SUBJECT: Appeal of Decision of the Historic Preservation Commission Concerning Property Located at 1176 Lullwater Road by Virginia Tate

Application to Appeal a Decision of the DeKalb County Historic Preservation Commission

Address of Property: _____ 1176 Lullwater Road, Atlanta, GA 30307

7-18 1176 Lullwater Road (DH), John Carpentier. Comment only on a proposed house location. 1235073 **For comment only**

APPROXIMATE LIMITS OF FUTURE 100 YEAR FLOOD HAZARD
AREA PER DEKALB COUNTY GIS MAPS. ELEVATION = 870.7

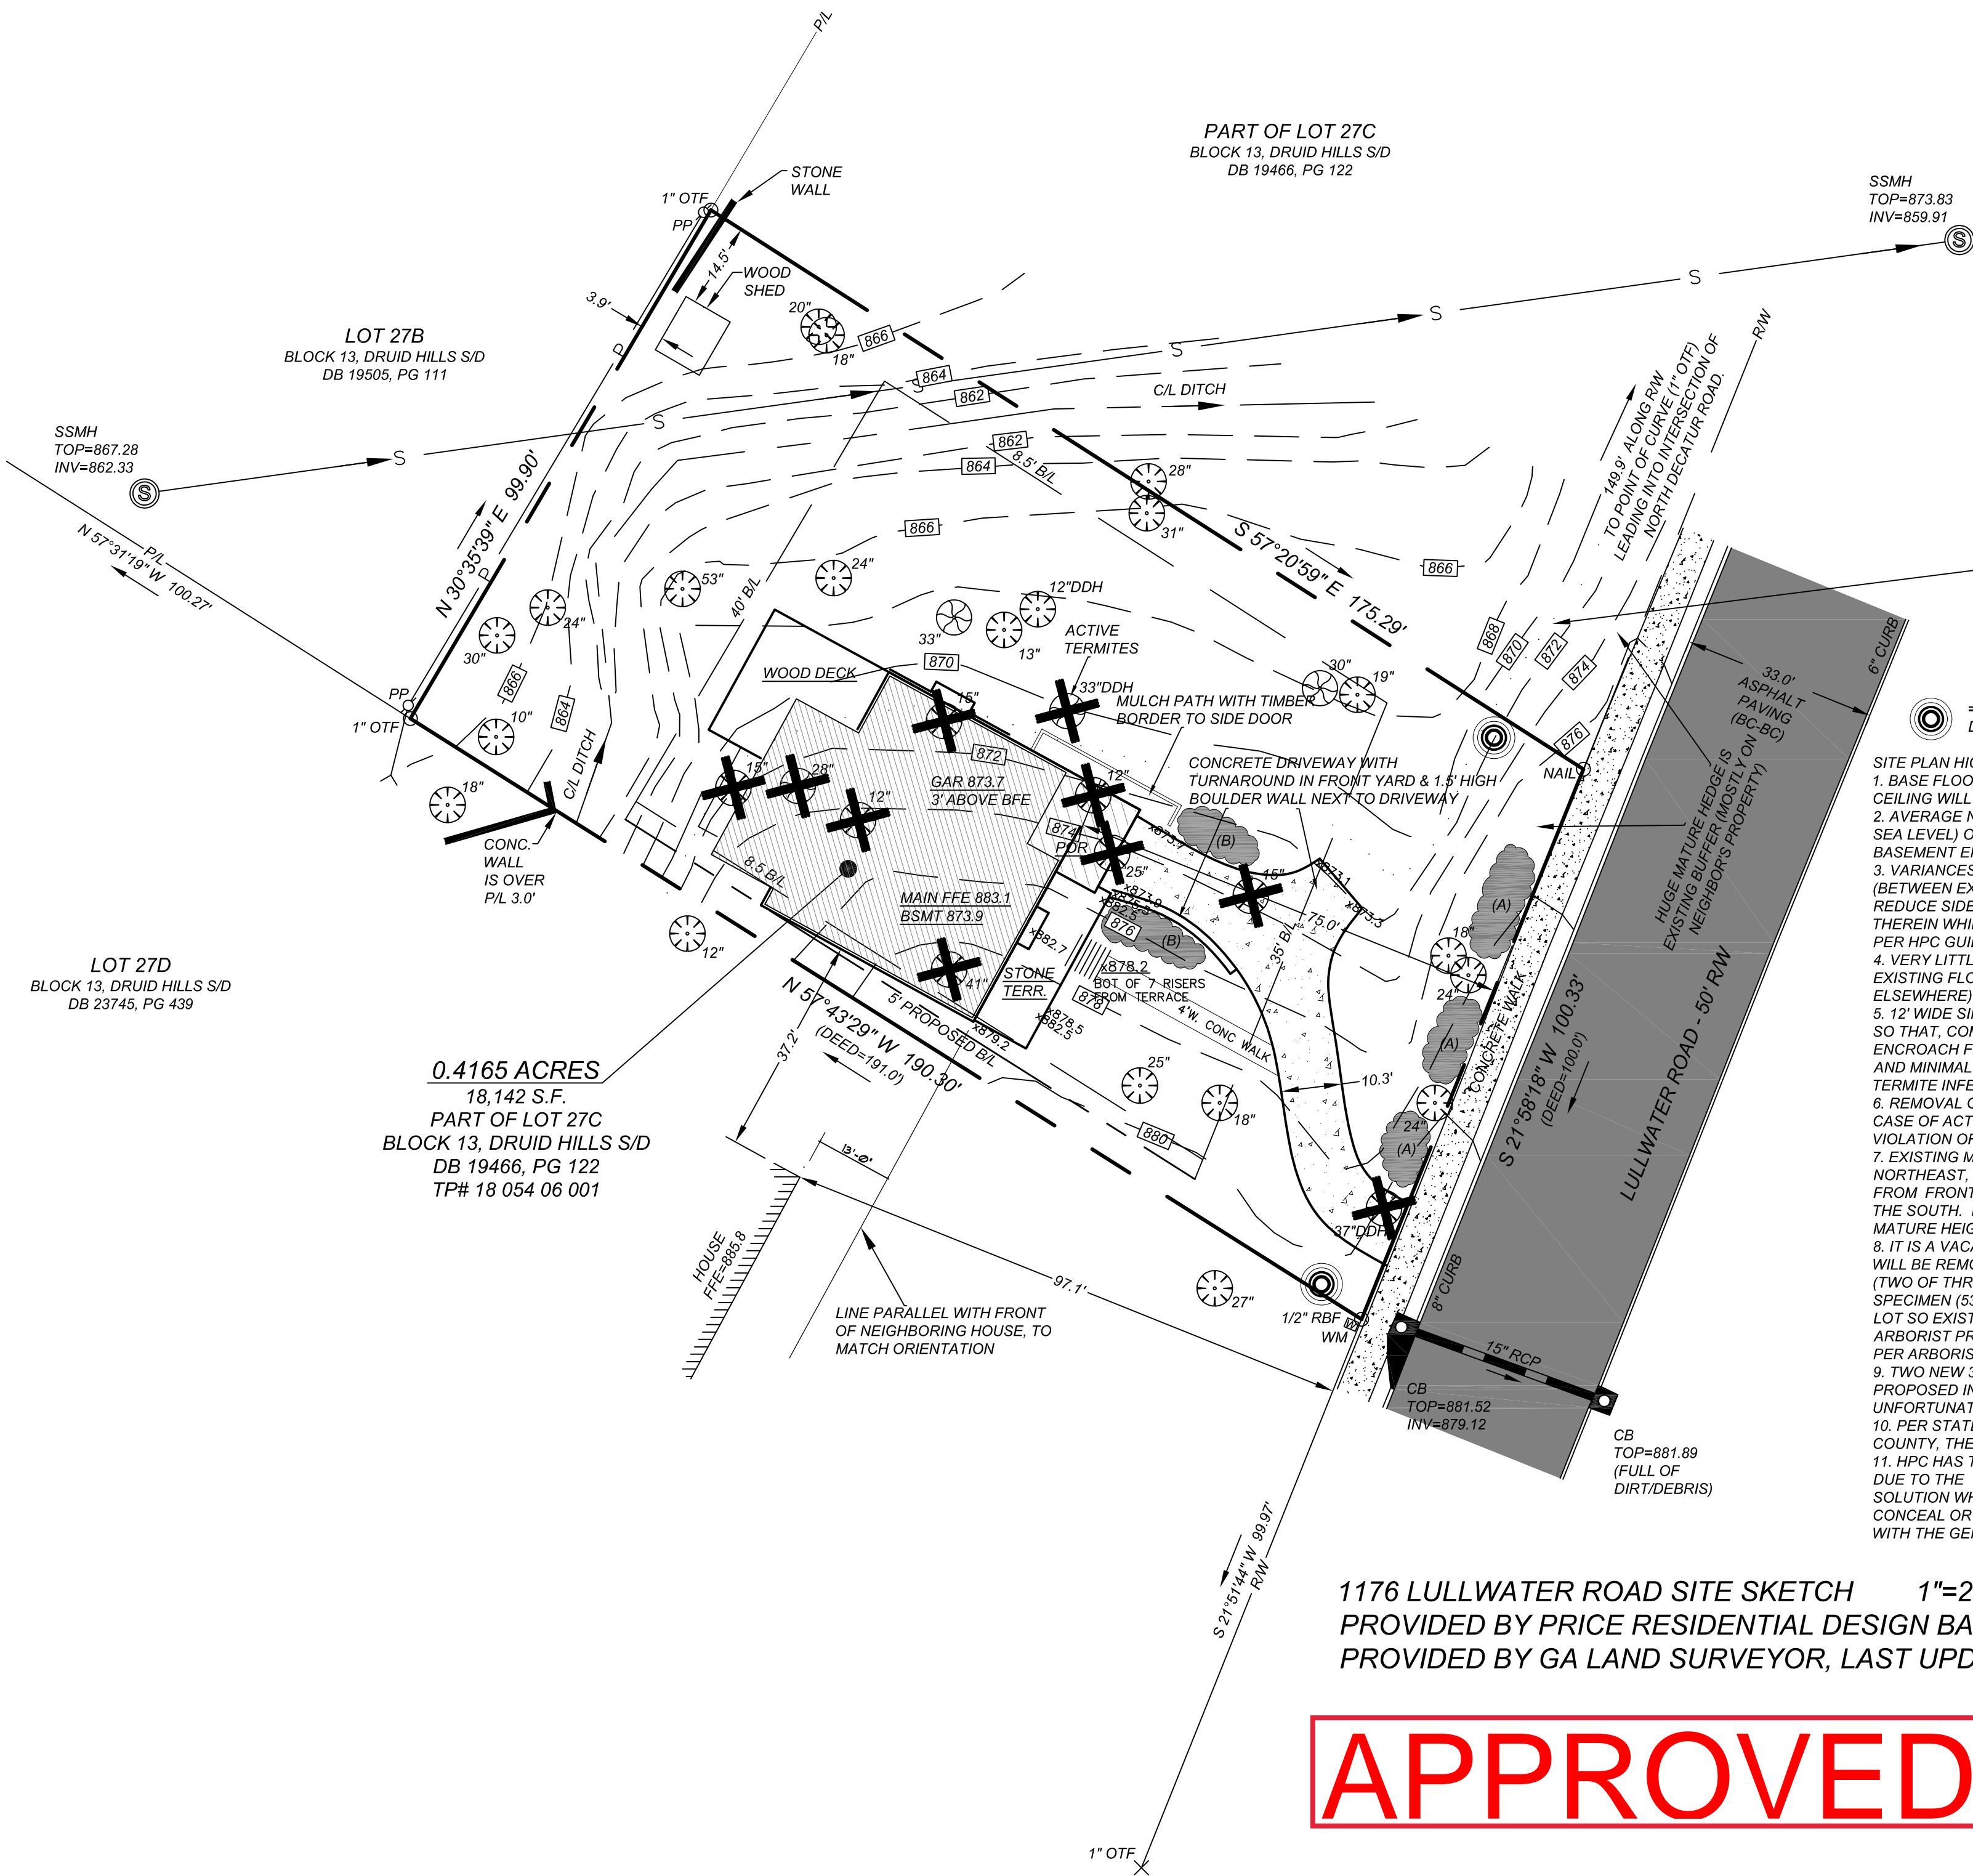
2) The HPC exceeded its authority since the site plan is no longer viable as the County just denied the Applicant’s request for a stream buffer variance.

On September 13, 2023 the County issued an administrative decision denying the stream buffer variance. The decision was based in part on the fact that the property is in the existing or year 2025 built-out condition flood plain and in part on the incompleteness of the application. Accordingly, the current site plan is not viable, and the HPC exceeded its authority by approving the COA.

The only difference between the two site plans is that the one before the HPC in September had the house 72 feet from the street as opposed to the 68 feet in the July 2023 application.

Appellant further submits that the HPC should not have approved the COA because the stream buffer variance was denied administratively¹ thereby allegedly rendering the site plan approved by the HPC "not viable". As noted by the HPC Chair and David Cullison stream buffer encroachment decisions are made separately by different departments than the HPC and have no bearing on whether a particular project

1176 LULLWATER ROAD SITE SKETCH 1"=20' 6-27-21 REVISED 7-9-21
PROVIDED BY PRICE RESIDENTIAL DESIGN BASED ON SURVEY INFORMATION
PROVIDED BY GA LAND SURVEYOR, LAST UPDATED 6-23-21

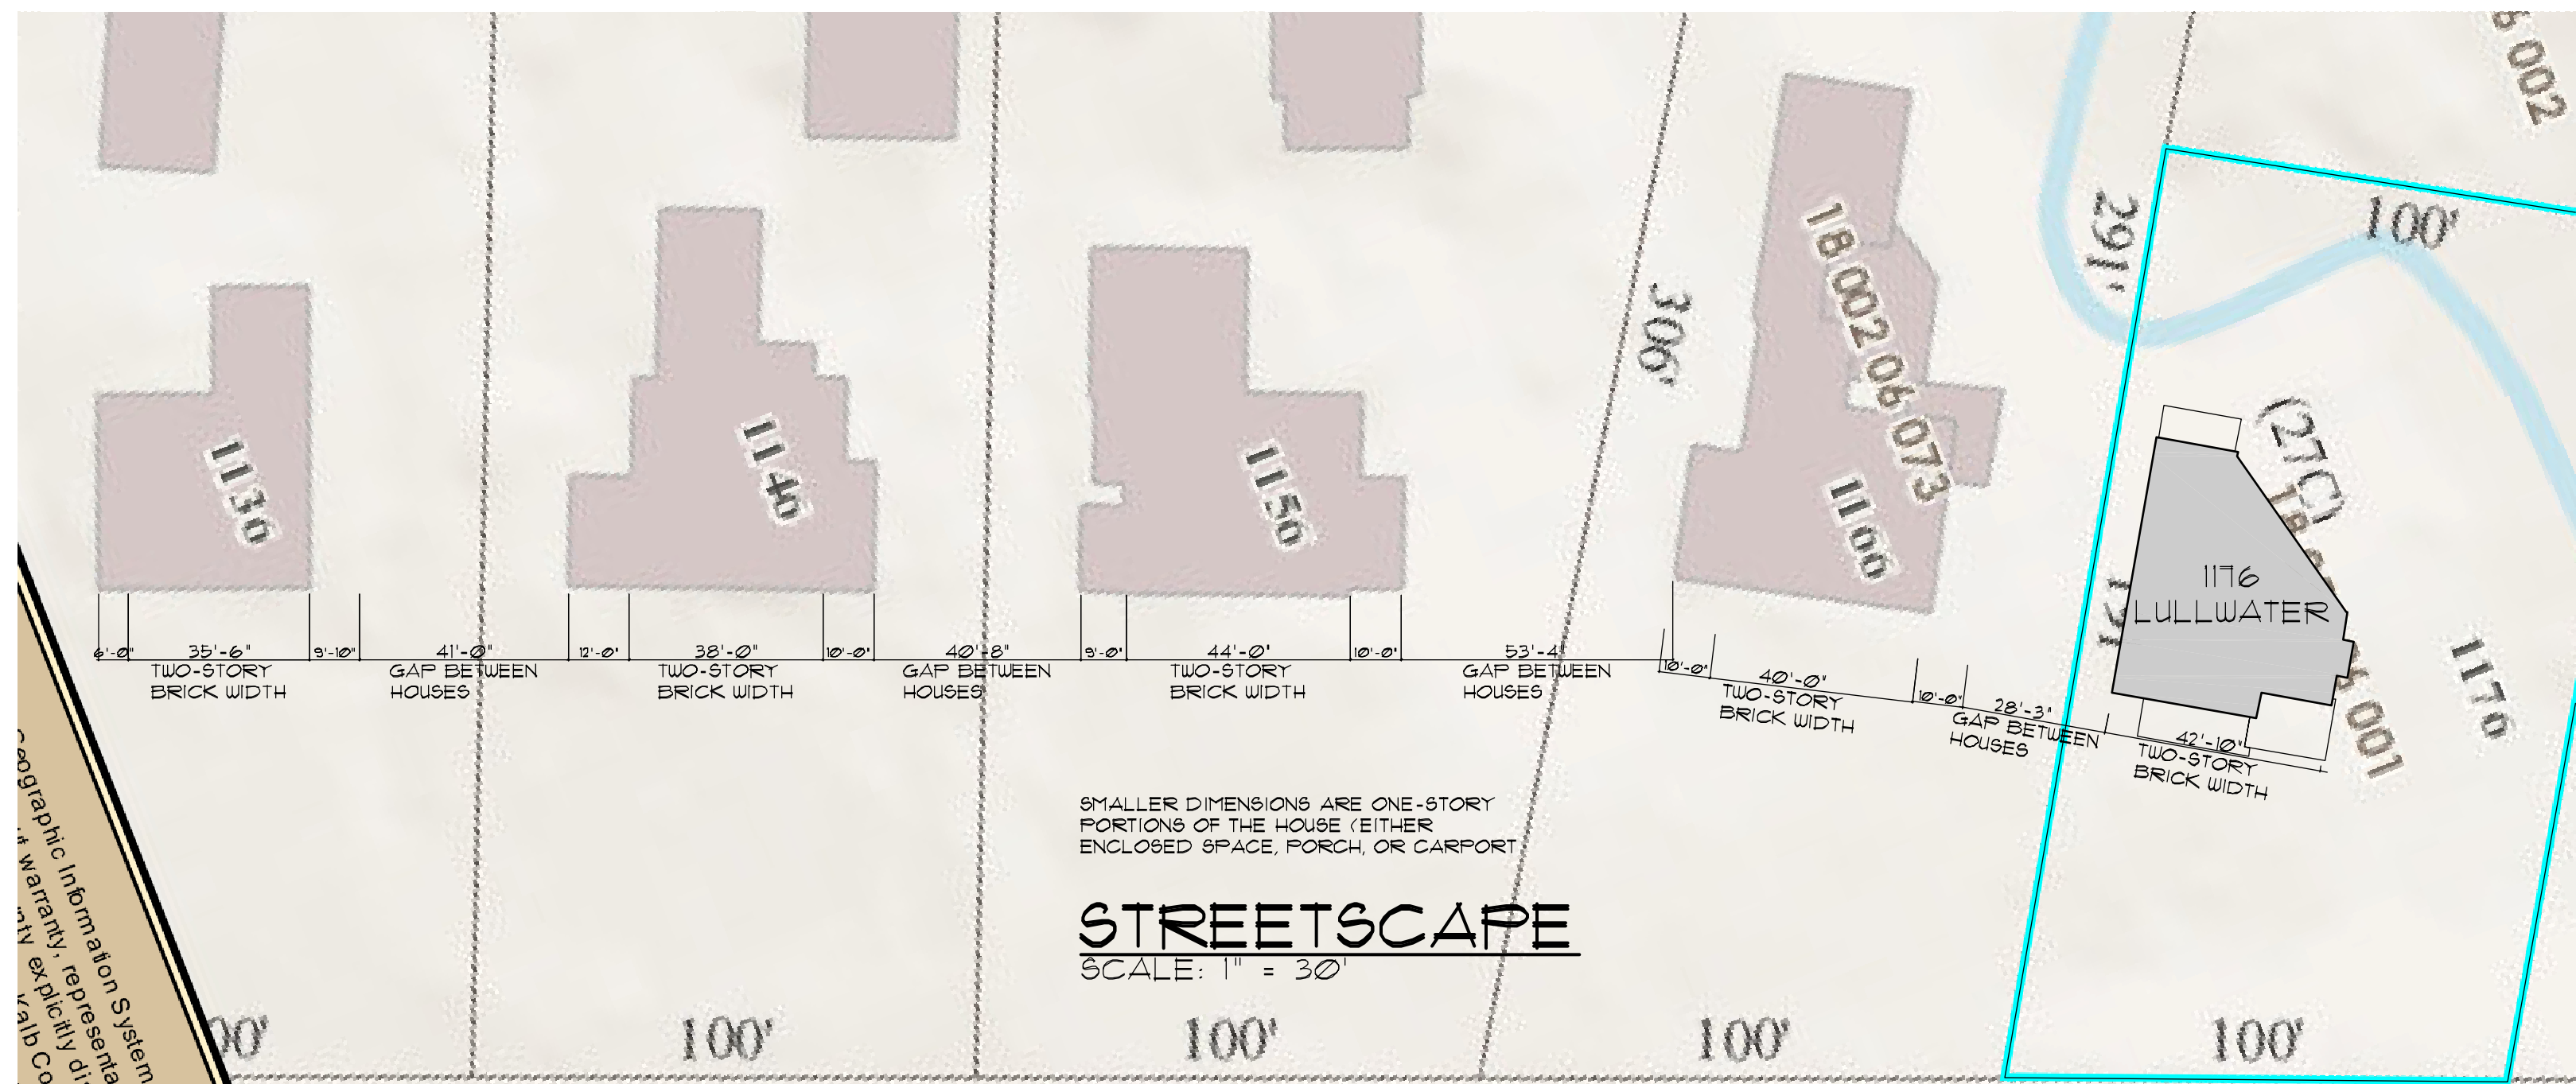
The HPC in its approval of the COA in September seemed to focus on an earlier approved COA from July 2021. However, since that COA from 2021, there has been a County requirement for a stream buffer on the property, the site plans have changes several times, and there have been two HPC denials of the request for COA (one in November 2021 and one in July 2023).

Because the HPC approved a plan almost identical to that submitted in 2021 it would have been arbitrary for HPC to not approve the 2023 plan submitted. Contrary to the assertion of the appellant that it was arbitrary for the HPC to ignore previous past denials of similar plans to those approved, it would have been arbitrary for the HPC to deny the plan approved due to the almost identical elements as a plan approved by the HPC in 2021. But for the lapse of time and the designation of a stream buffer on the Subject Property where before there had been none, the applicants could have moved forward with implementation of the HPC plan approved in 2021. See staff report in this regard. The Subject Property is considered a buildable lot by the County and the applicants are considered to have a right to build on it. Recording at 30:11 and 41:03. The proposed front façade is the similar to that which was approved in July 2021. At the July 2021 HPC meeting, a version of the proposed home was approved for a COA that was 690 square feet larger, 30” wider, and 30” taller to the ridge than the home approved by the HPC on September 18, 2023. See comparison of front elevations –approved in 2021 vs. approved in 2023. The location proposed in 2023 is 7.65 feet from the property line as opposed to 5 feet in the previously approved 2021 application. The nearest part of the house to the right-of-way is 72’, 3’ closer than the previously approved house. See page 7 of application showing the site plan “Approved July 2021”.

FRONT ELEVATION
 NOT TO SCALE

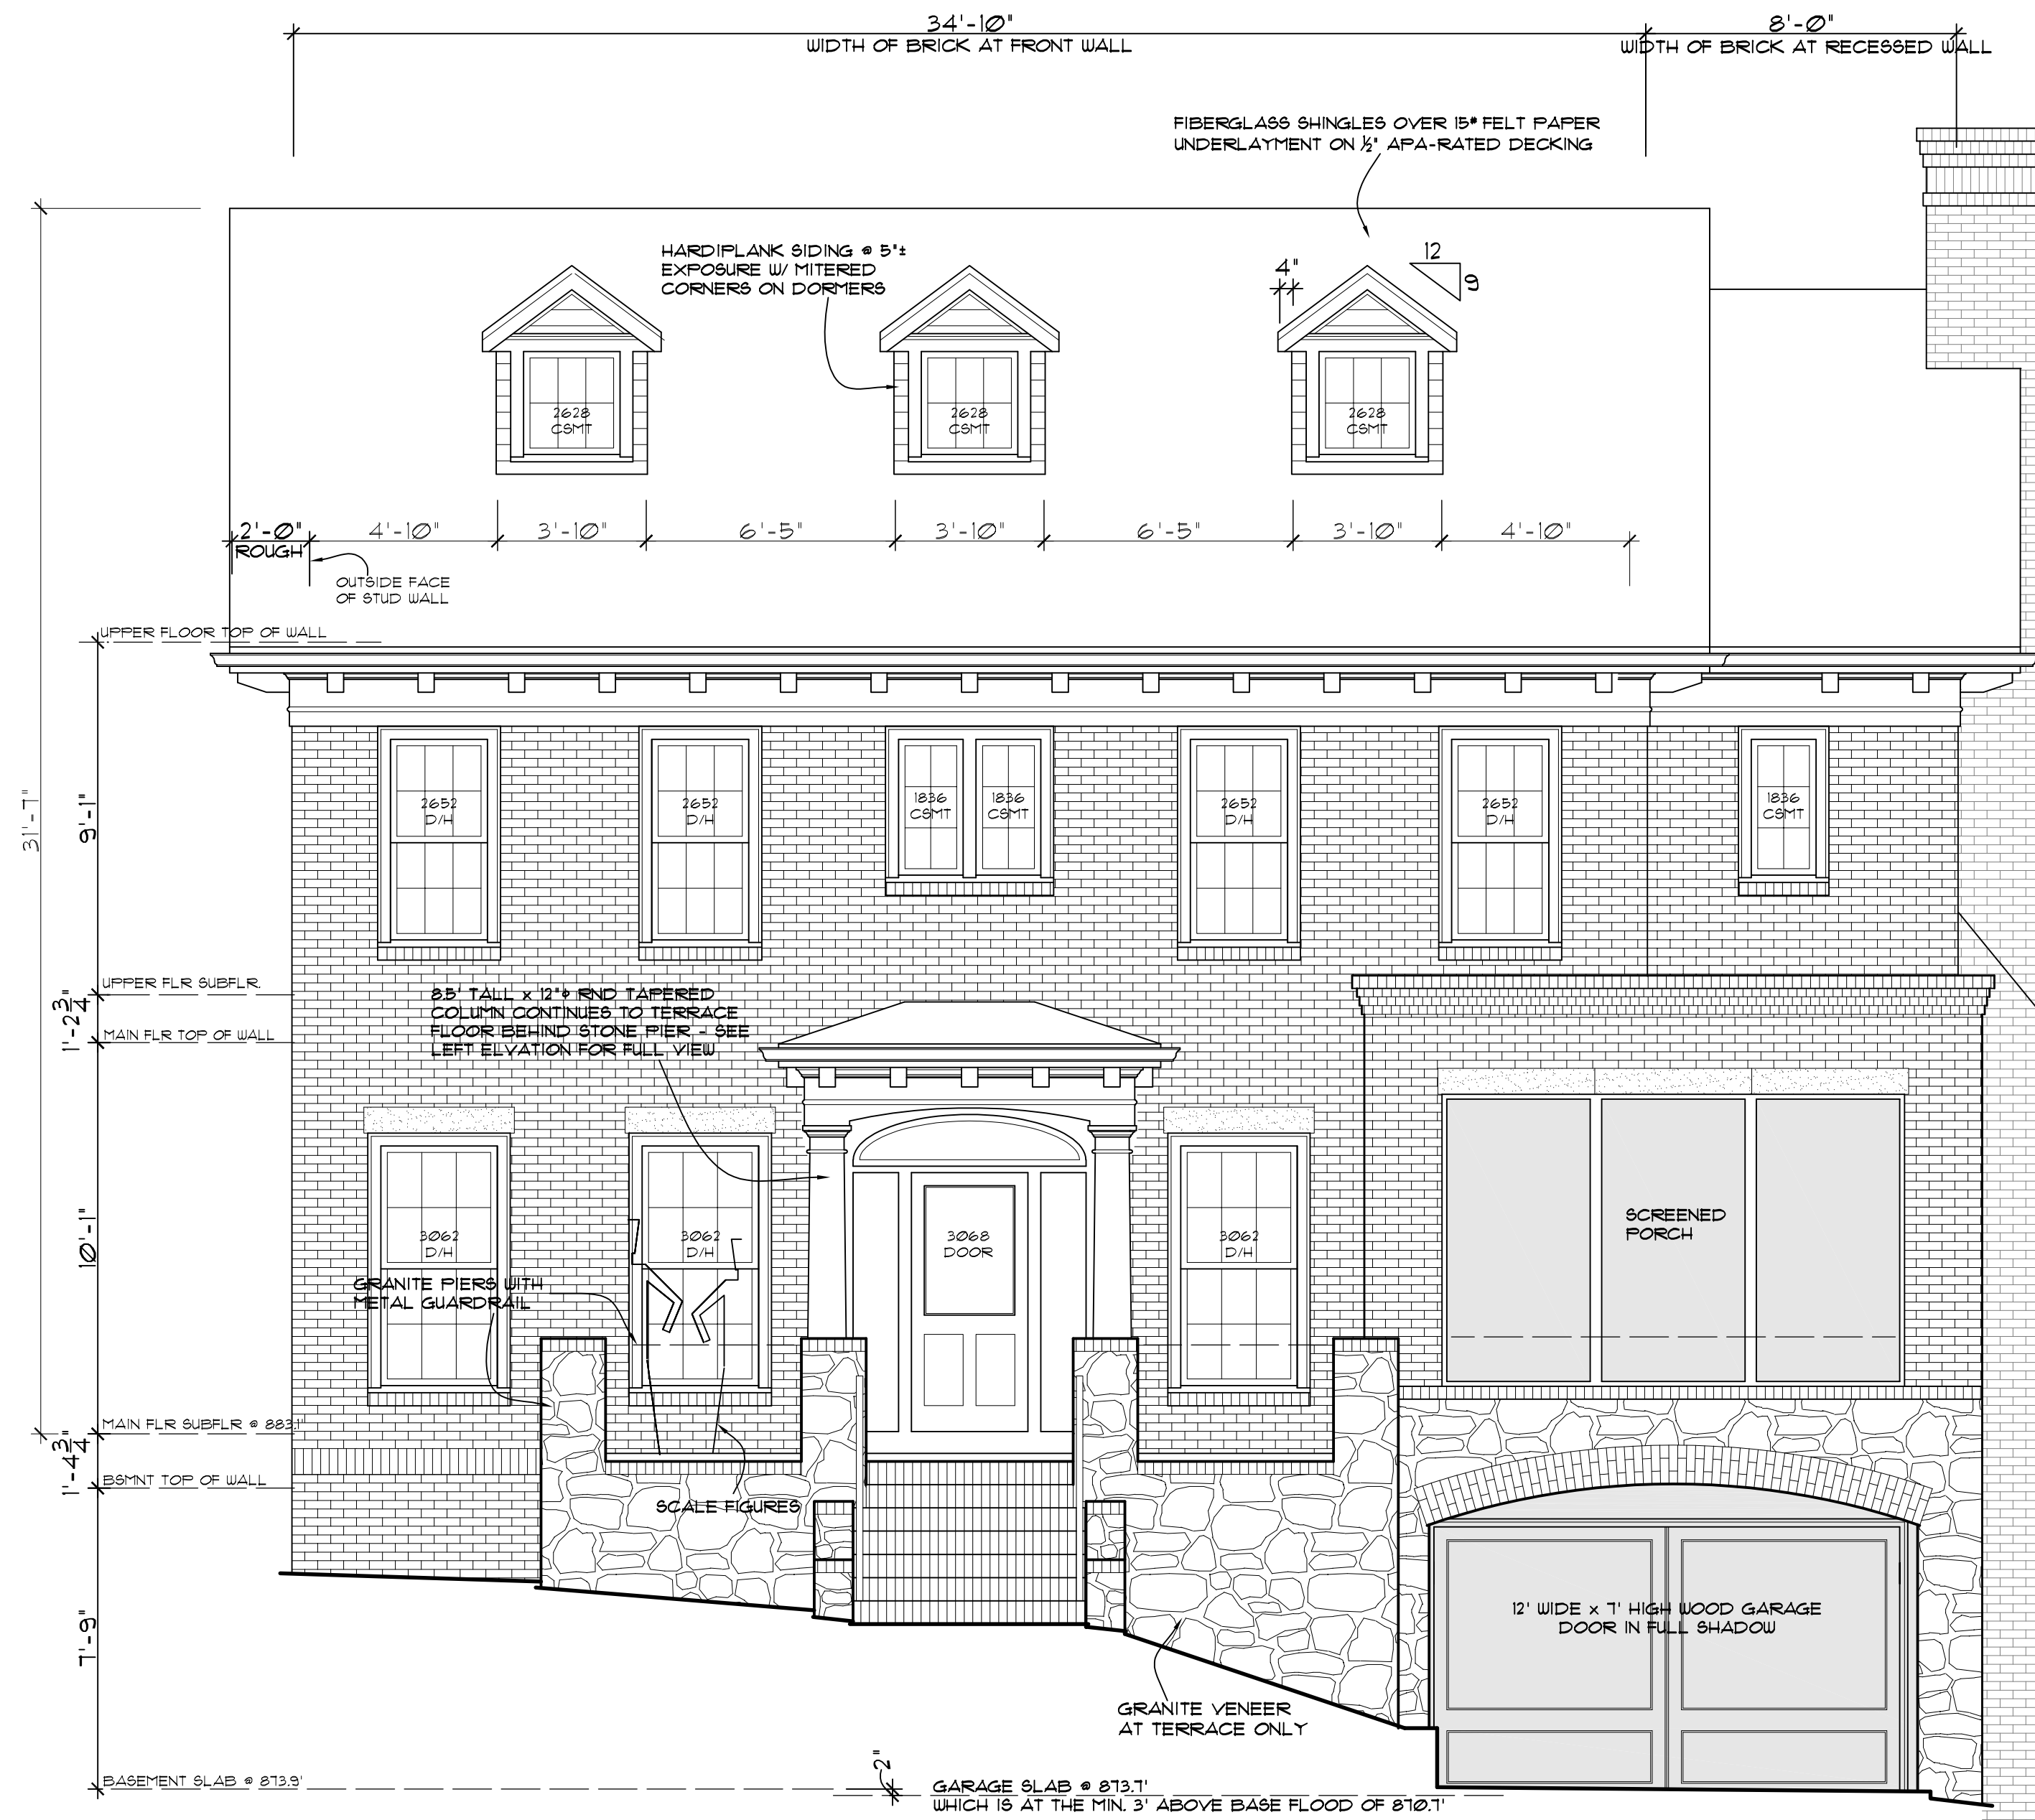
Build a house as shown in the architectural drawings with the modifications that the granite shown on the front and left side of the house will be replaced with brick and the small window on the right side of the front elevation will be replaced by a larger window matching the others on the façade.

Build a house as shown in the architectural drawings with the modifications that the granite shown on the front and left side of the house will be replaced with brick.
